PC 11/18/10  
#11

RE: **Sundance Subdivision: Z07-0040 /TM07-1454/S09-0012**  
**Groundwater Impacts:**

# **Analysis of Groundwater Availability and Recharge in the Sundance Project Area**

By: Bill Bennett, CE, GE

Figure 7

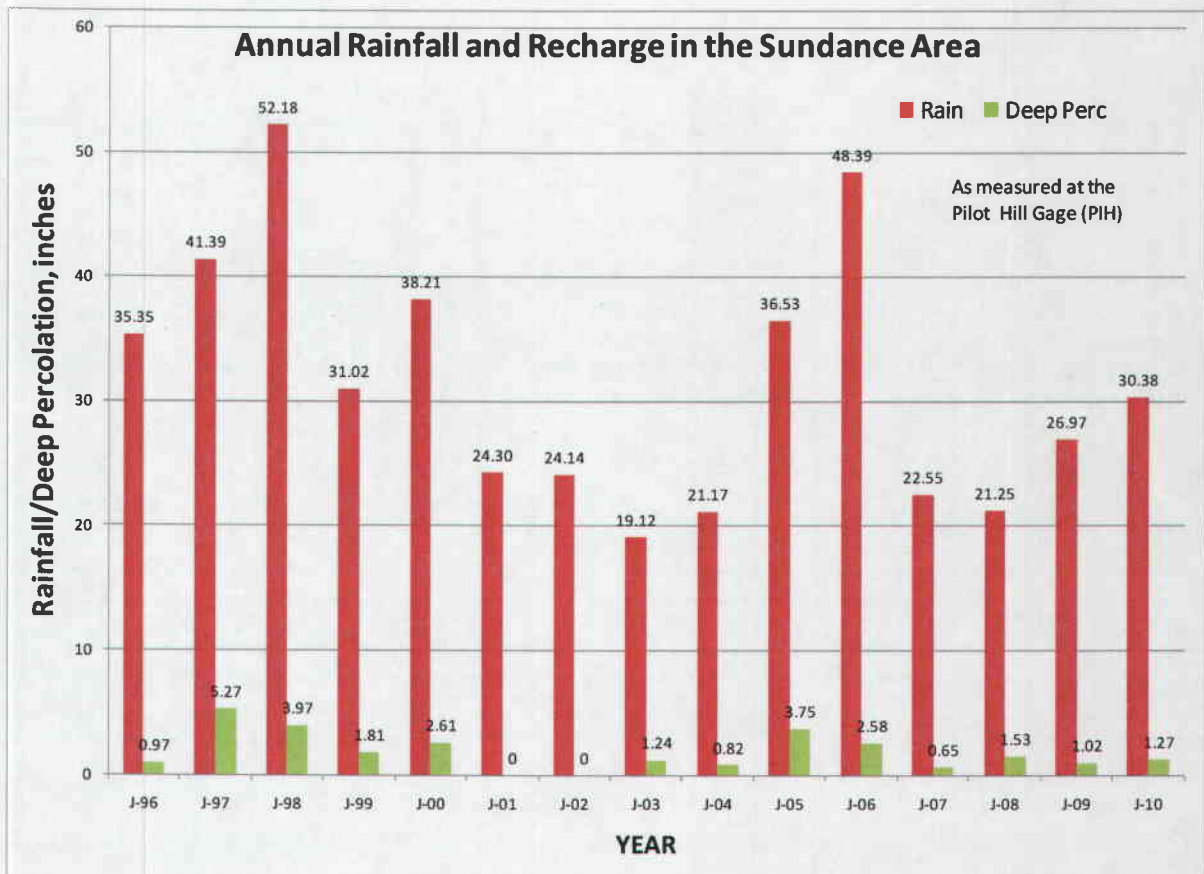
Figure 7 provides a summary of the calculated annual rainfall and calculated deep percolation for the years 1996 through 2010. Note that the groundwater recharge is not necessarily proportional to the annual precipitation. This is not surprising since the amount of infiltration and deep percolation is dependent on how the precipitation is distributed over time.

Figure 8

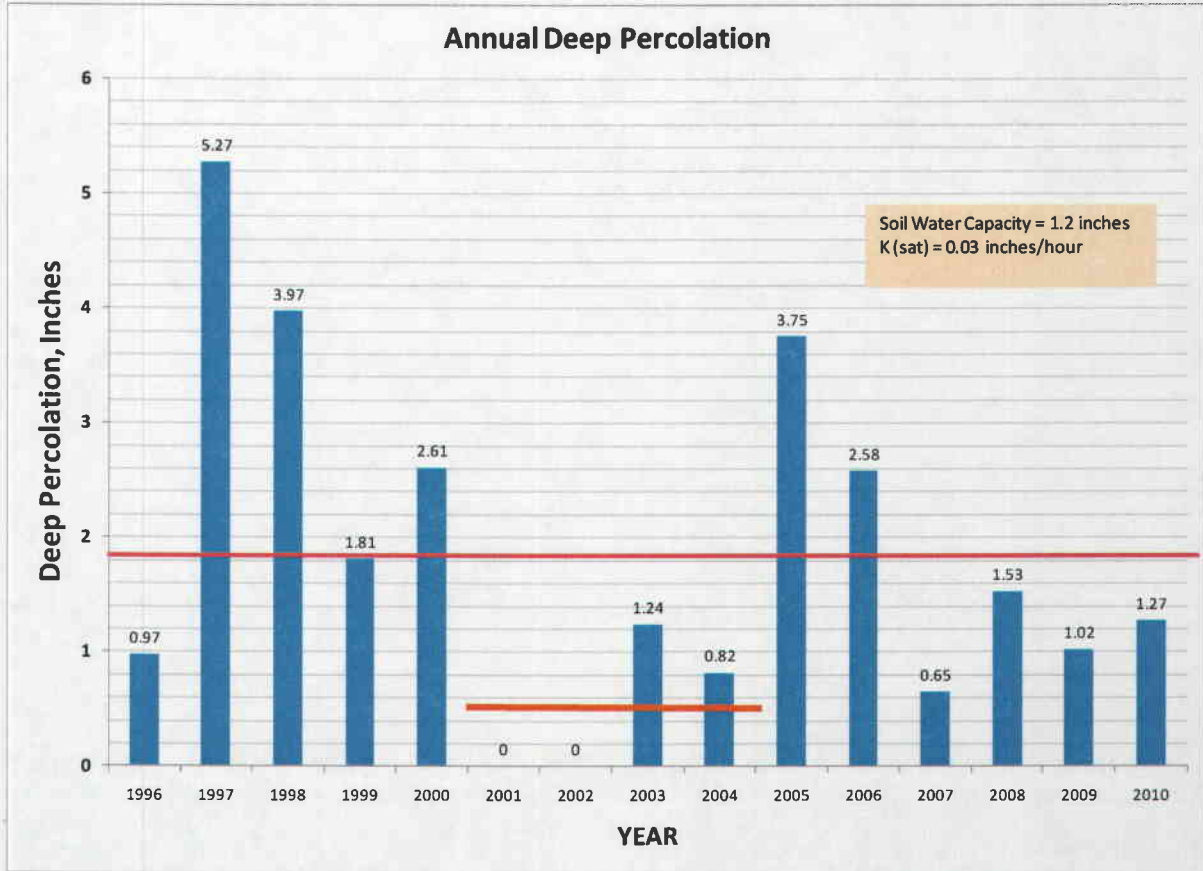
Figure 8 shows just the calculated annual deep percolation for the study period. For these soil characteristics, the average calculated recharge for all 15 years is about 1.8 inches (red line). However, the plot also shows the recharge varies significantly from year to year. There are many consecutive years where the recharge is much lower than the average. For example, during the period 2001 through 2004, the deep percolation averages only 0.5 inches

(orange line) and obviously much lower if one were to look only at 2001 and 2002. Even over the last 4 consecutive years the deep percolation has only been 60% of the long term average.

However, as discussed earlier, the significant variation in annual recharge. There are two examples shown in Figure 8 of four year periods that have average recharge values significantly less than the long term average and of course many single years where recharge is even lower. Looking at the period of 2001 through 2004, the factor of safety for groundwater use would be:

**Figure 9 Sundance and Surrounding Parcels (Analyzed Area)**

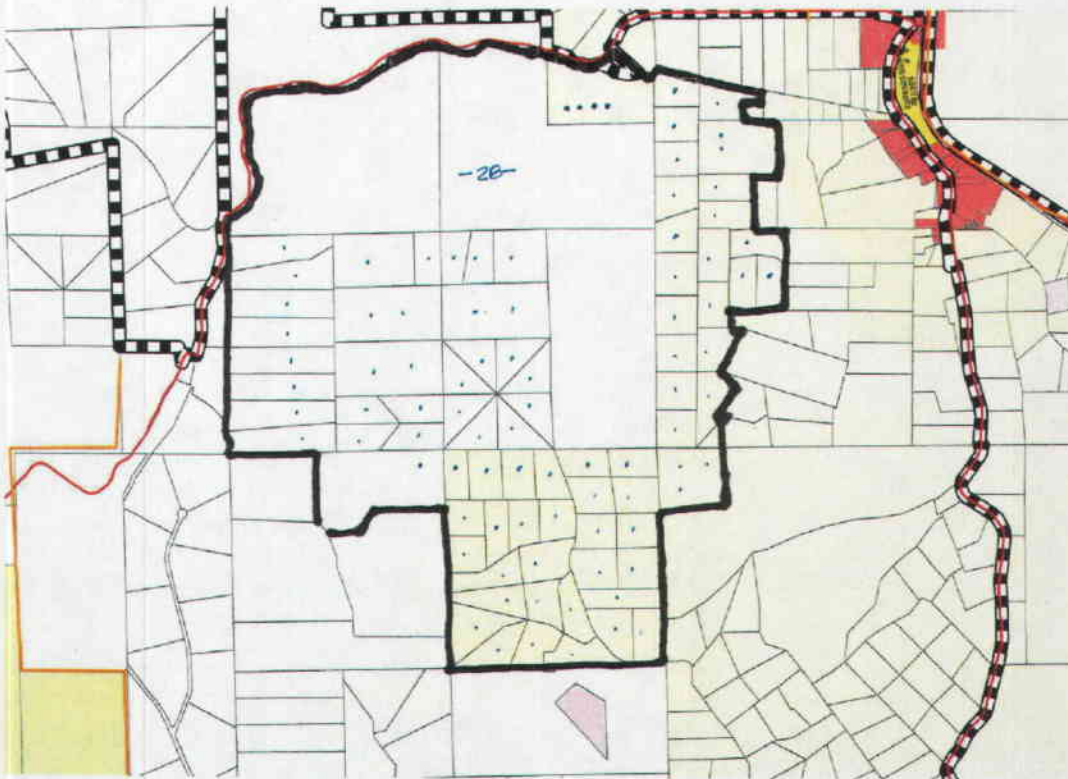
Figure 6 shows the Sundance and surrounding area, including the parcels on the Pilot Hill ridge. Figure 9 is a parcel map of the area that corresponds to the soil map presented in Figure 6. The current Sundance plan calls for 28 dwellings and the surrounding properties shown in the figure can accommodate another 89 primary dwellings, not including granny flats. Thus, a total of 117 primary dwellings will need to rely on groundwater in the future for this area, which has a surface area of about 895 acres.

We can calculate a factor of safety to compare the available groundwater with the future water demand. A factor of safety of 1.0 means that there is just enough groundwater to satisfy the water demand for the area.

Using the long term average calculated recharge (1.8 inches) and a use factor of 0.75 a-ft per dwelling, the factor of safety for groundwater use would be:

$$FS = \frac{(1.8 \text{ inches} / 12 \text{ in/foot}) \times 895 \text{ ac}}{0.75 \text{ a-ft/unit} \times 117 \text{ units}} = 1.5$$
